**CITY OF SOMERVILLE, MASSACHUSETTS**  
**MAYOR'S OFFICE OF STRATEGIC PLANNING & COMMUNITY DEVELOPMENT**  
**JOSEPH A. CURTATONE**  
**MAYOR**

**Case #:** ZBA 2016-78-R1(6-2018)

**PLANNING STAFF REPORT**

**Site:** 104 Beacon Street\*

**Figure A** ZBA-approved plans from January 18, 2017 showing four (4) on-site parking spaces.

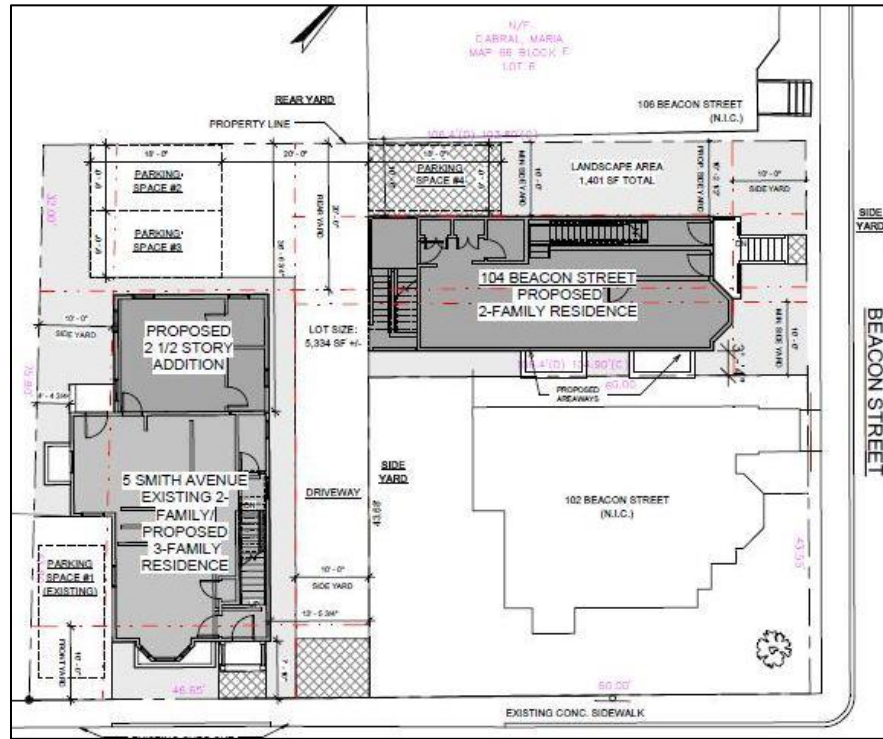
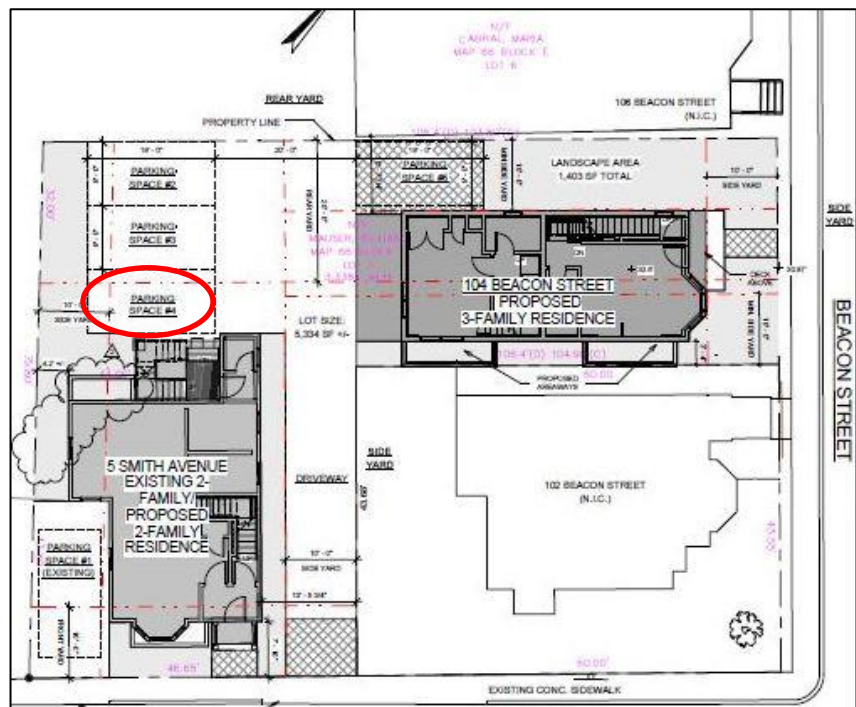
**a. The Applicant Shall [sic.] provide at least one off-street parking spot per unit.**

The Applicant is able to provide one additional on-site parking space due to removing a previously-approved rear addition on 5 Smith Avenue. Staff would prefer to see this new parking space area instead used as green space. *However*, providing one parking space per residential unit is consistent with the ZBA's interest in providing the same. Staff finds that the additional parking space will potentially prevent one extra vehicle from parking on surrounding city streets.

**Figure A** – Approved January, 2017

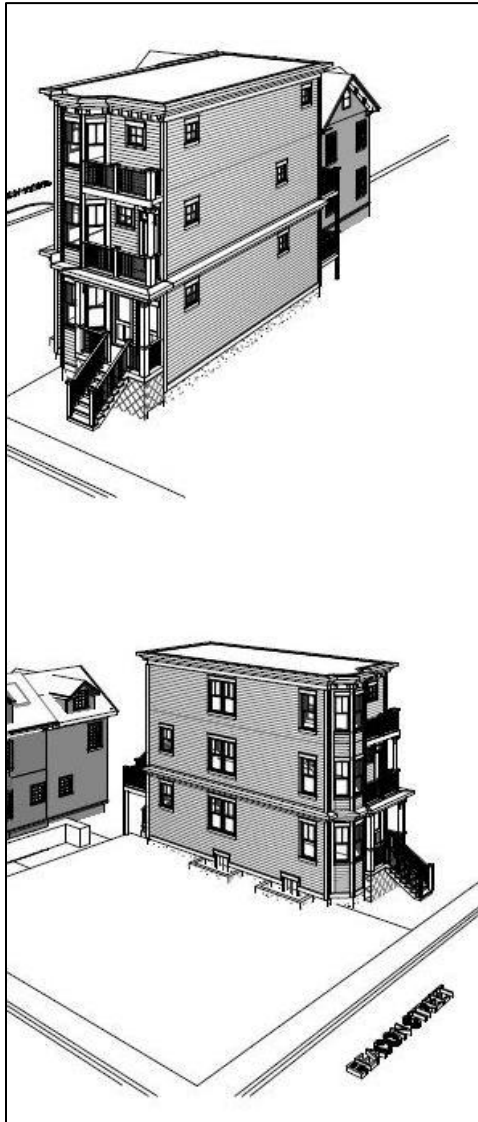
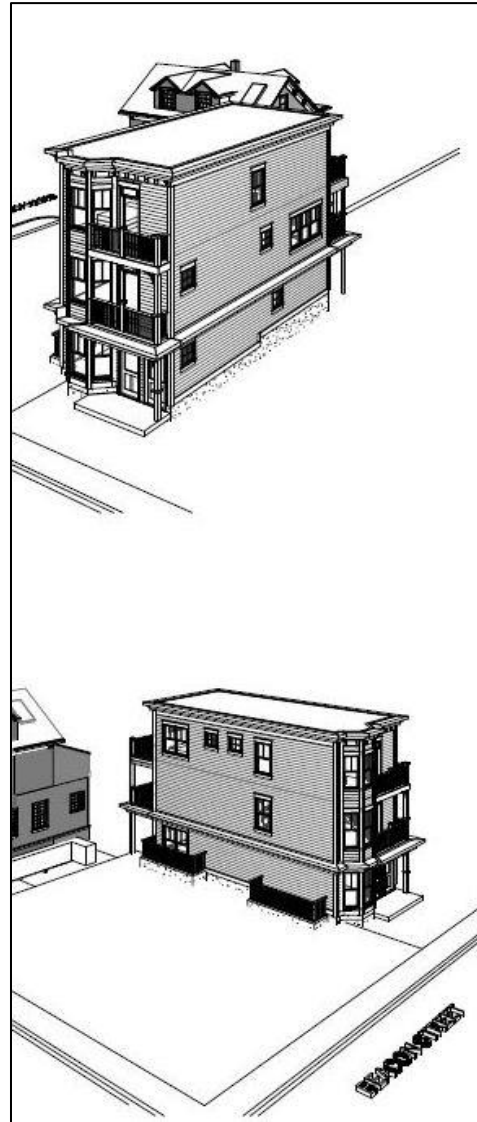
### **b. The style of 104 Beacon Street shall match the triple-deckers to its northwest on Beacon Street, as shown on the Applicant's plans dated December 13, 2017, and the Applicant shall use a paint color of a shade designed to blend in with the neighborhood, as approved by the City of Somerville Planning Department.**

There are no plans in Staff's possession from December 14, 2017. The most recent set of plans that staff has are from January, 2017 and July 11, 2018. **Figure A** on the left below reflects the approved January, 2017 triple-decker design for 104 Beacon Street. **Figure B** on the right reflects the proposed changes to the 104 Beacon Street triple-decker. Primary differences between the approved triple-decker and the proposed triple-decker are:

- length of the building
- size of the egress areaways on the left elevation of the building
- window arrangements
- building height lowered/elimination of front steps
- inclusion of second- and third- story rear decks running the length of the length of the building

Staff finds that the proposed July, 2018 triple-decker offers improvements on the original design in terms building appearance window arrangement, specifically on the left elevation of the building, and massing. The massing at the rear of the building is improved by opening up the rear to provide deck space instead of interior living space.

**Figure B** – Proposed July, 2018

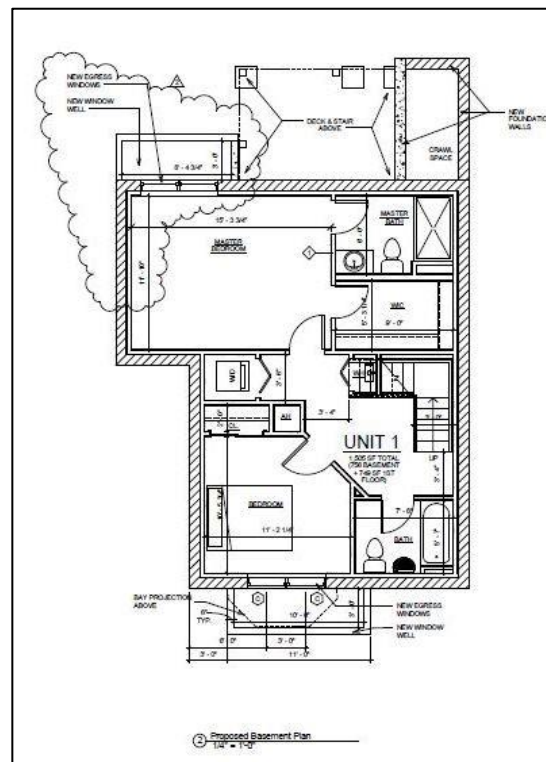
Staff finds that the re-location of the window well alleviates this specific issue along the left elevation of 5 Smith Avenue.

**Figure A – Approved January, 2017**

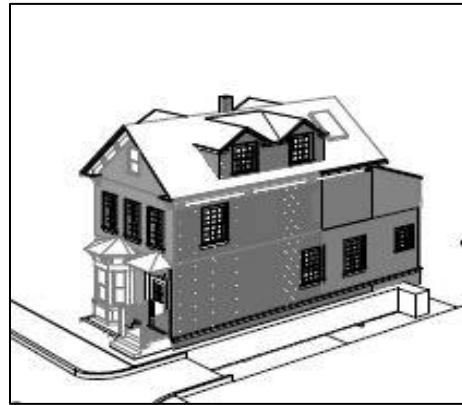
- d. **The Applicant shall replace the two chimneys on 5 Smith that are scheduled for removal with dummies that will help preserve the visual symmetry between 5 Smith and 9 Smith. *The architect has indicated that this will be feasible and the developer has tentatively agreed to do so.***

Originally, the January, 2017 approved proposal for 5 Smith Avenue called for the removal of the existing chimney stack on the building. The proposed plans for July, 2018 show the installation of one faux chimney stack in the location of the existing chimney. **Figure A** below shows the approved plan for 5 Smith Avenue from January, 2017 without the chimney stack. **Figure B** below shows the proposed plan for 5 Smith Avenue from July, 2018 with the faux chimney stack installed.

Staff is supportive of the recommendation to install a faux chimney. The faux chimney shall be designed with the proportions and decoration (if any) that was typical to a working-class Italianate structure of the 5 Smith Avenue time period. The developer will accomplish this by working with the Planner-Preservation Planner and in conjunction with the Secretary's Standards as noted in conditions #20 and #21.

**Figure B – Proposed July 2018**

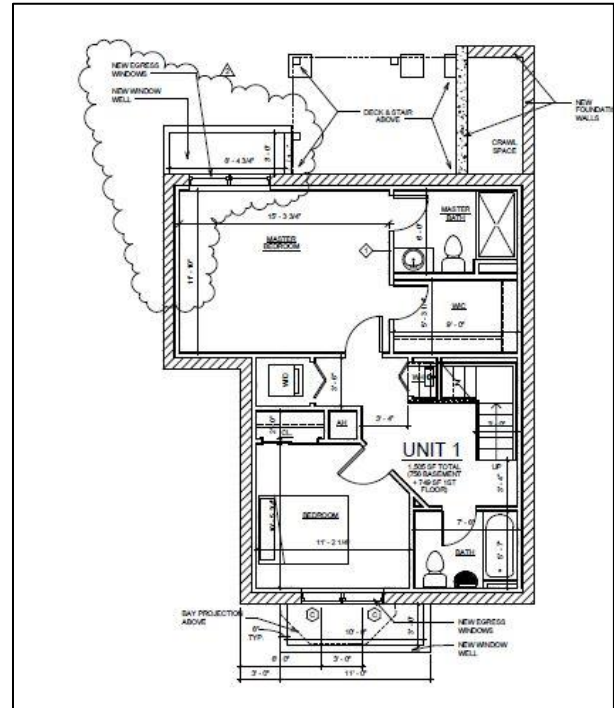
- a. The Applicant shall preserve more outdoor space by limiting the footprint of 5 Smith Avenue and 104 Beacon Street to no more than the size shown on the Applicant's plans dated December 14, 2017.**

As stated earlier in this report, Staff is not in possession of plans dated December 14, 2017. Staff is in possession of the approved plan set from January, 2017 and the proposed plans for July, 2018. The building footprint in the proposed plans for July, 2018 are largely the same except for what appears to be the removal of a bump-out on at the back portion of the right façade of the building. **Figure A** below shows the existing footprint of 5 Smith Avenue and **Figure B** shows the proposed footprint of same.
